CANNONDESIGN

Field Report

DATE	Dec. 13, 2016	**REPORT NO.**	**005**
PROJECT:	Webster University Interdisciplinary Science Building 8274 Big Bend Blvd. Webster Groves, MO 63119	**DATE OF VISIT:** **TIME:** **WEATHER:**	Dec. 13, 2016 3:40 pm 35°F Cloudy
PROJECT #	004560.01		
PRESENT AT SITE:	Kelvin Patel (CD), Lynn Grossman (CD) Steve Ray (Paric)

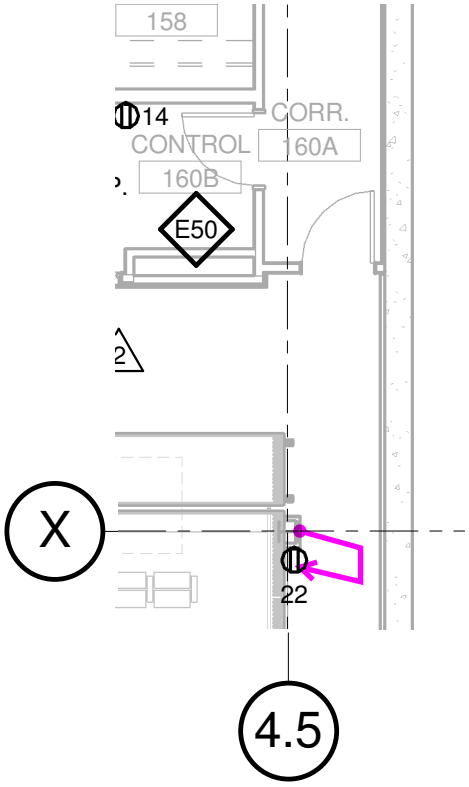
1. At level 01, Electrical oultet on column at col. line 4.5 and X is not located per documents. It is currently on the corridor side.
ACTION: Contractor to move the electrical outlet on south side of the column per documents.

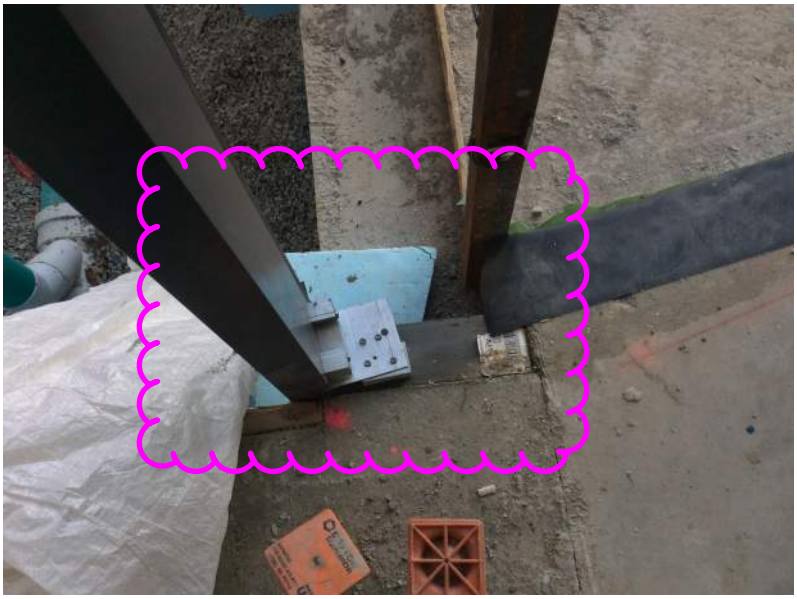
4. All level 02, no concrete floor / substrate below curtainwall end near column line 5 and B.
ACTION: Provide solid floor or substrate for curtianwall support and installation of AVB.
